Tahlequah Casino Addendum 17

Date: July 20, 2018

Electrical

CHEROKEE NATION ENTERTAINMENT
TAHLEQUAH CASINO
TAHLEQUAH, OKLAHOMA

E6.2
1/8" = 1'-0"
ENLARGED LIGHTING PLAN - SOUTH

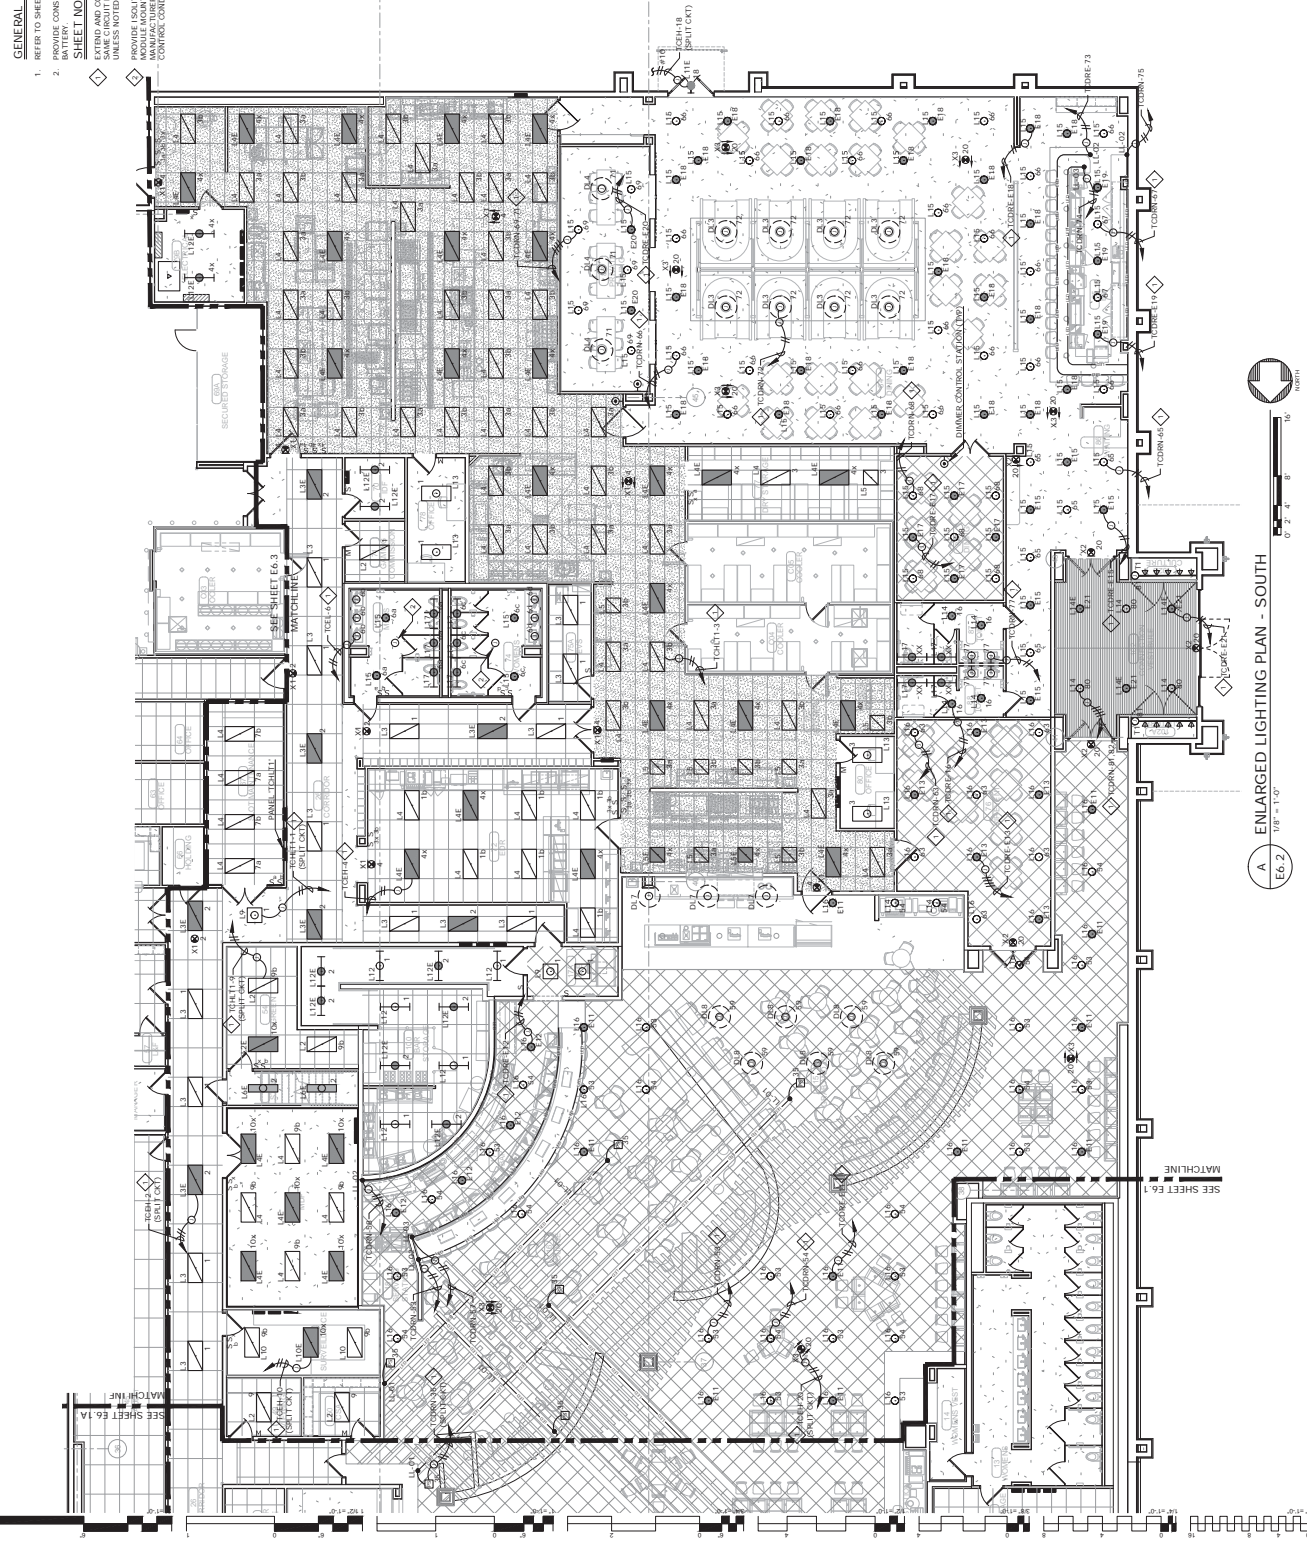
- E6.1 Added/deleted/relocated light fixtures, switches and circuiting based on updated architectural backgrounds.
- E6.2 Revised entire sheet.
- E6.3 Revised architectural background.

E6.4
ENLARGED LIGHTING PLAN - BANQUET BOH
1/8" = 1'-0"
0' 2' 4' 6' 8' 10'

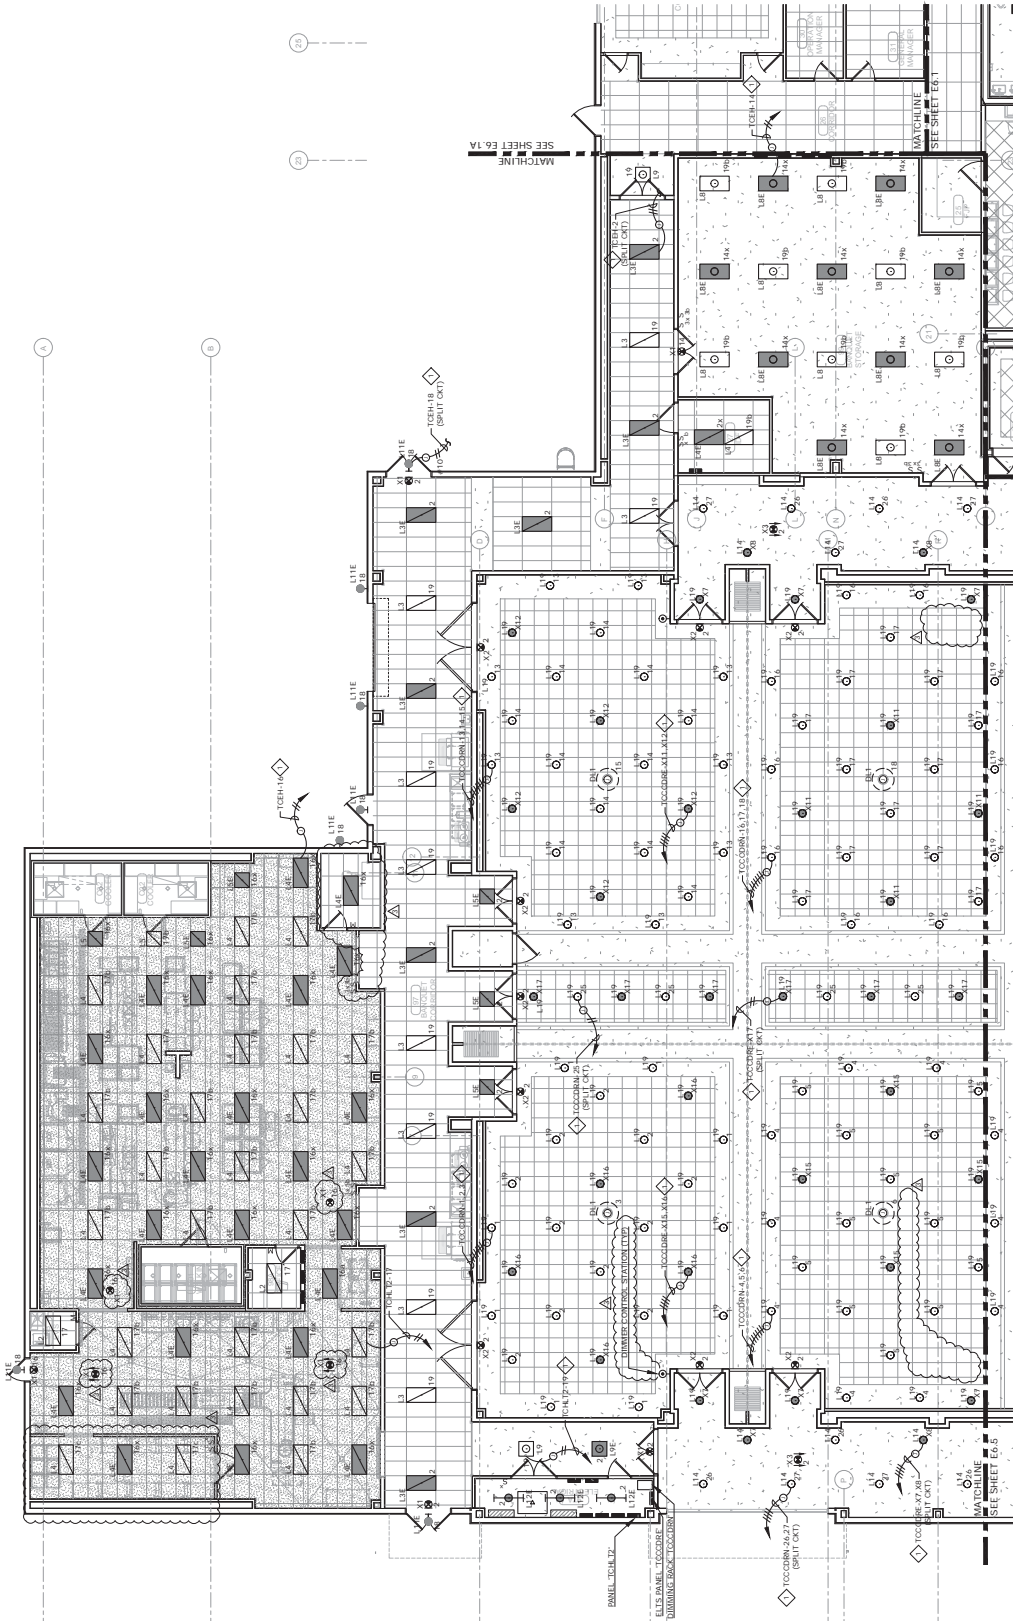
- E6.4 Added/deleted/relocated light fixtures, switches and circuiting based on updated architectural backgrounds. Deleted dimmer system control stations as indicated based on update architectural backgrounds.

ENLARGED LIGHTING PLAN - NORTH
E6.5
1/8" = 1'-0"
NORTH

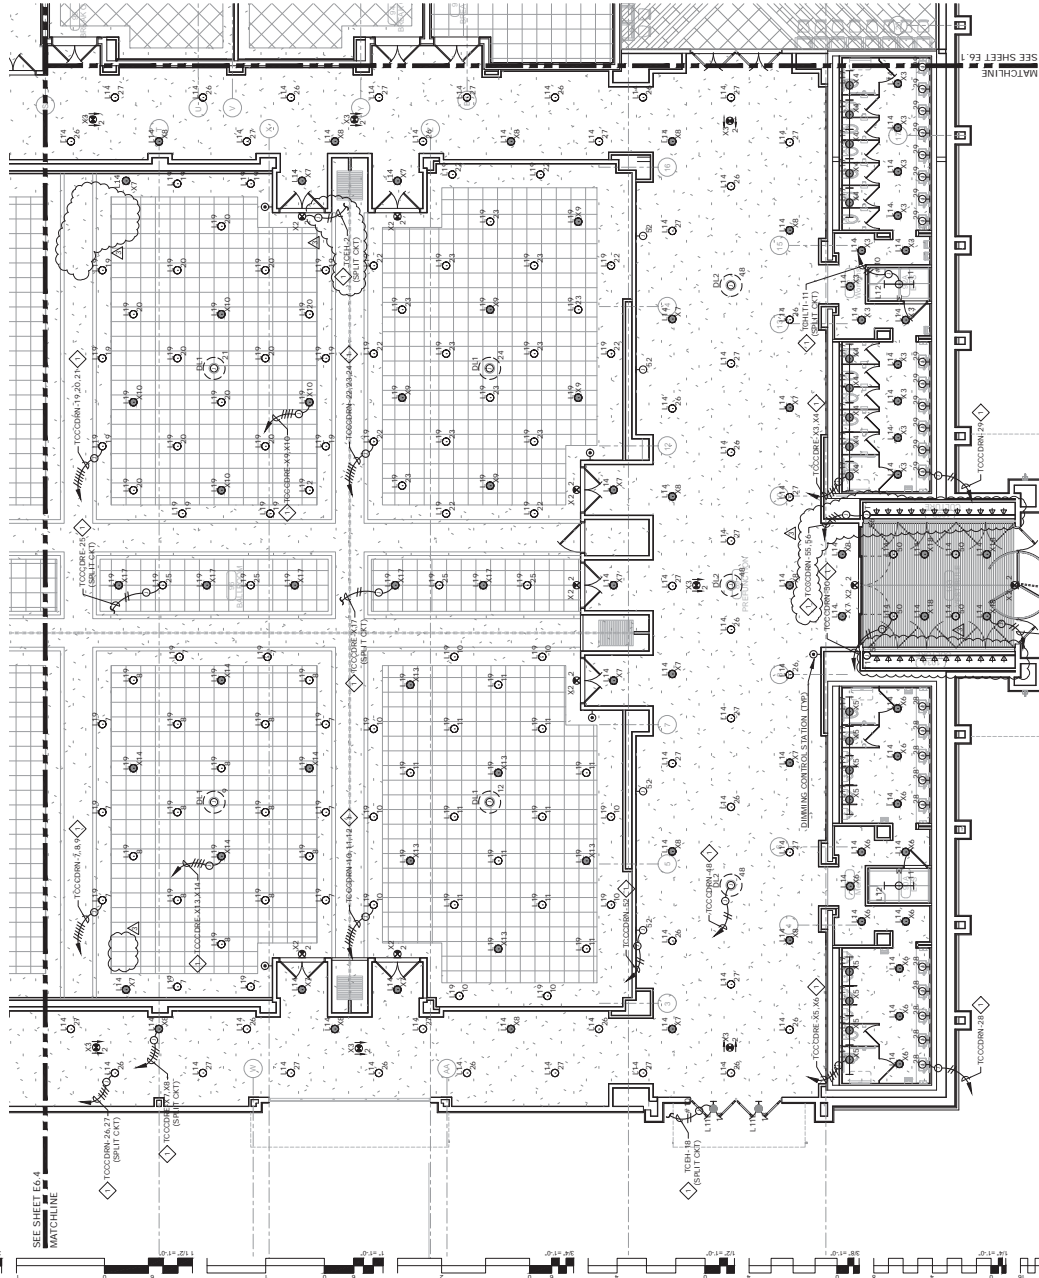
- E6.5 Added/deleted/relocated light fixtures, switches and circuiting based on updated architectural backgrounds. Deleted dimmer system control stations as indicated based on update architectural backgrounds.

DATE: 08/03/18
DRAWING NO.: 17-466
PROJECT: EFS120
FOODSERVICE ELECTRICAL CONNECTION PLAN

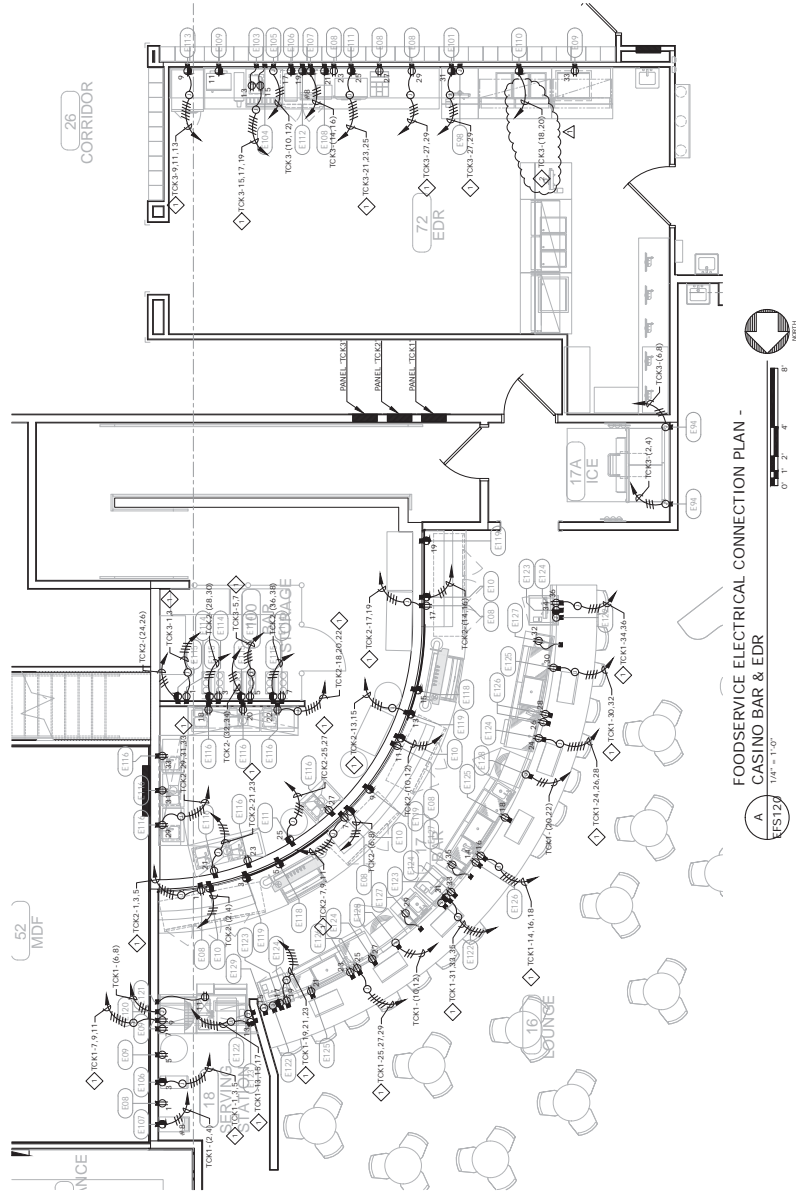
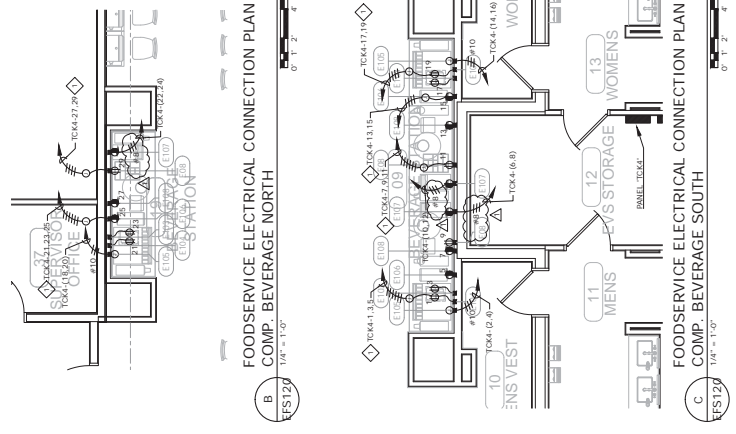
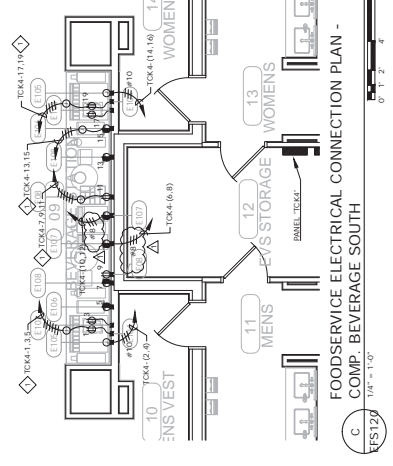
- EFS120 Added/deleted/revised electrical connections and circuiting for food service equipment based on food service consultant coordination. Added Sheet Note 2 as indicated.

**FOODSERVICE ELECTRICAL CONNECTION PLAN -
GRAB-N-GO KITCHEN**
A
EF5121
1/4" = 1'-0"

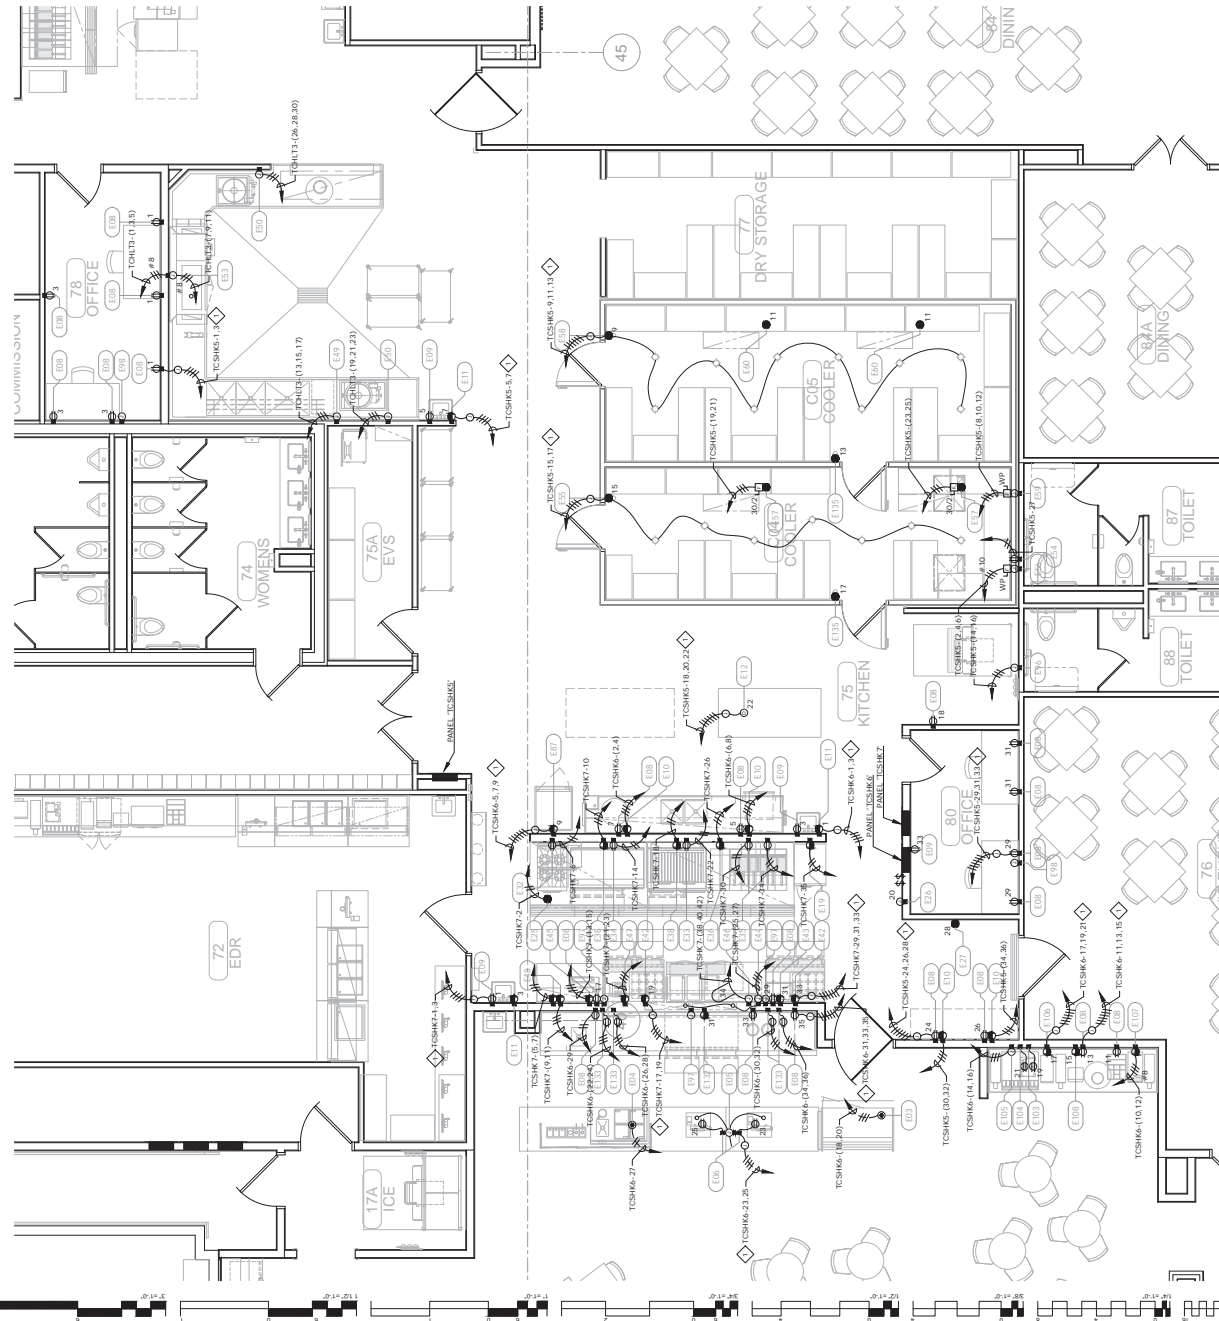
- EFS121 Added/deleted/revised electrical connections and circuiting for food service equipment based on food service consultant coordination.
- EFS122 Deleted light fixtures and circuiting based on owner accepted VE.

**FOODSERVICE ELECTRICAL CONNECTION PLAN -
WAREHOUSE**
SCALE: 1/4" = 1'-0"
EFS123

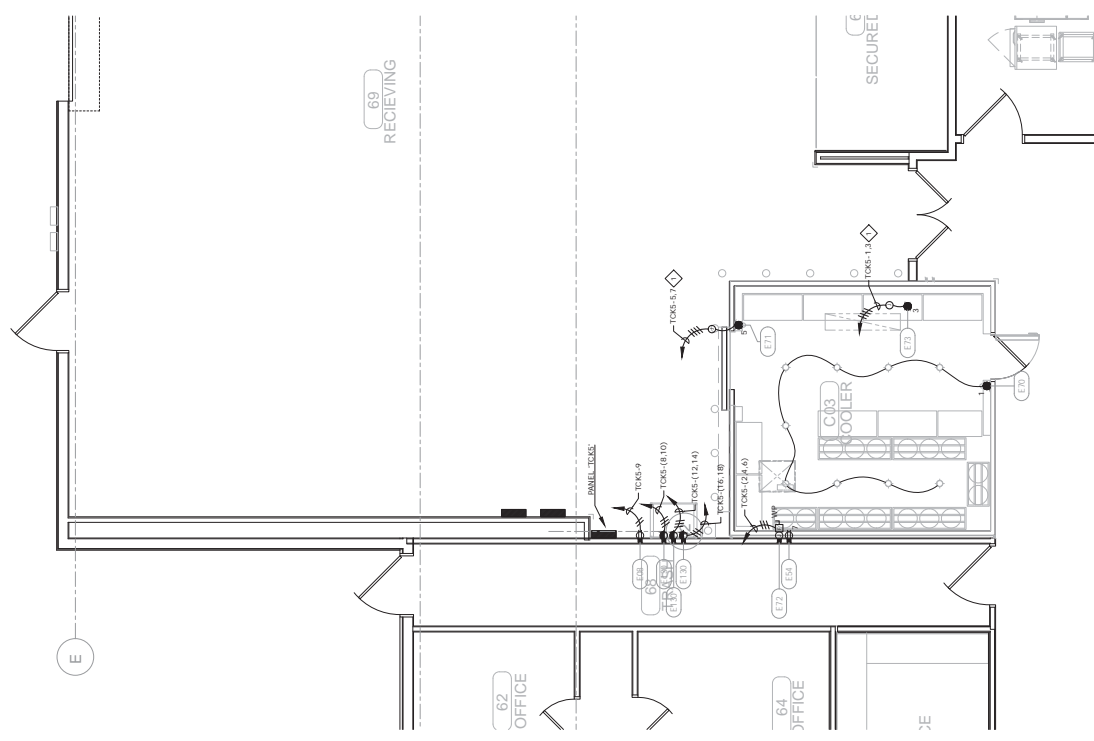
- EFS123 Revised entire sheet.
- EFS124 Added/deleted/revised electrical connections and circuiting for food service equipment based on food service consultant coordination.
